TECHNICAL EVALUATION REPORT
VOGTLE ELECTRIC GENERATING PLANT
UNITS 1 & 2
STATION BLACKOUT EVALUATION

Final
August 22, 1991

U.S. Nuclear Regulatory Commission
Washington, D.C. 20555

Figure 1: Voltge Electric Generating Plant Unit 1 and Unit 2 Main One Line Diagram (FSAR Figure 8.3.1-1)

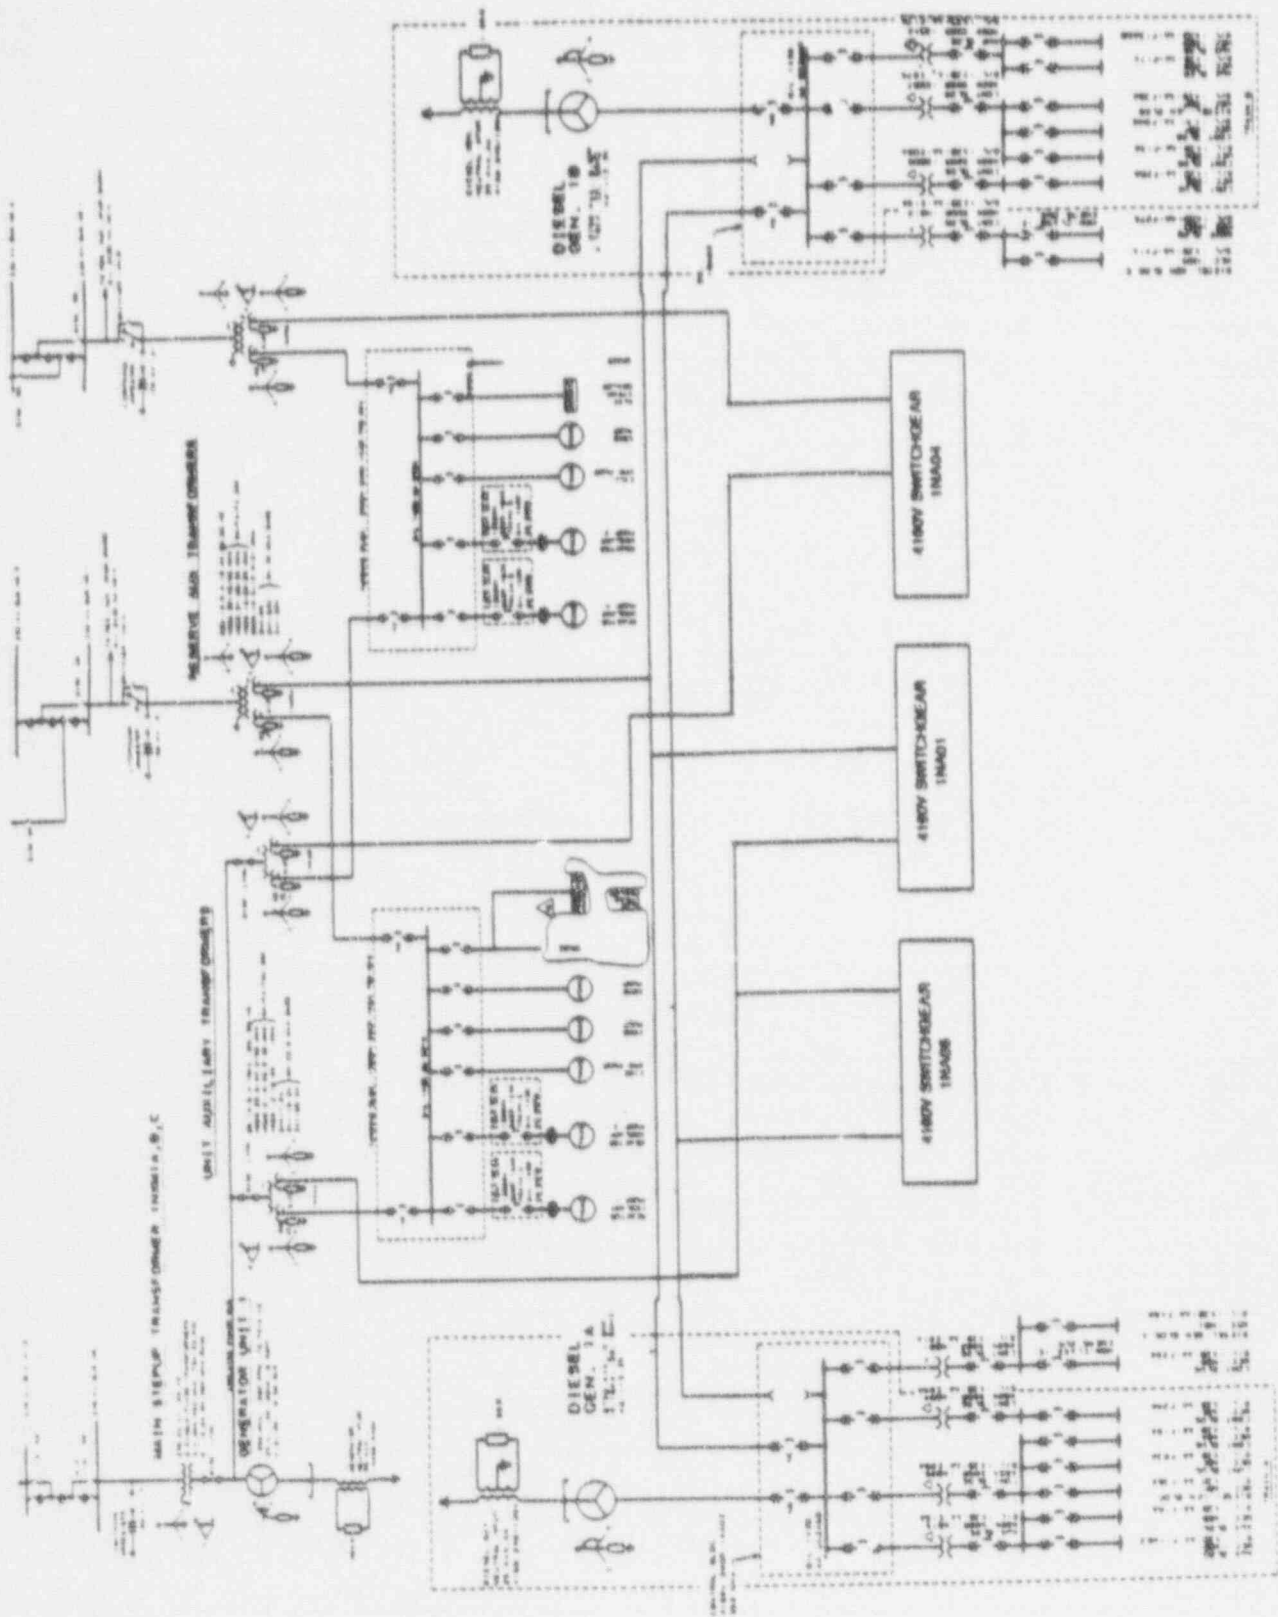
The licensee stated that the independence of the plant offsite power system grouping is "11/2." A review of the Vogtle FSARU shows that, see Figure 1 (12):

1. The site has 500 kV and 230 kV switchyards which are electrically connected.
2. Each unit is equipped with two reserve auxiliary transformers (RATs).

3. One RAT from each unit (a total of two RATs) is powered from a separate offsite power source.
4. Each emergency bus is normally connected to one RAT, and each RAT has the capacity to supply both emergency busses.
5. Upon loss of power from one of the RATs, there is a manual transfer to an alternate power source (redundant RAT). The licensee stated (15) that this transfer is proceduralized and involves racking out the breaker in the 4160 V class-1E switchgear and racking it into an empty cubicle in the same switchgear. This transfer takes approximately 15 minutes.

Based on the above, the plant independence of offsite power system group is "I2." This determination is based on the guidance of Table 5 of RG 1.155, and the NUMARC 87-00 Supplemental Questions and Answers (11) guidance regarding the timing of manual transfer to an alternate required power source.
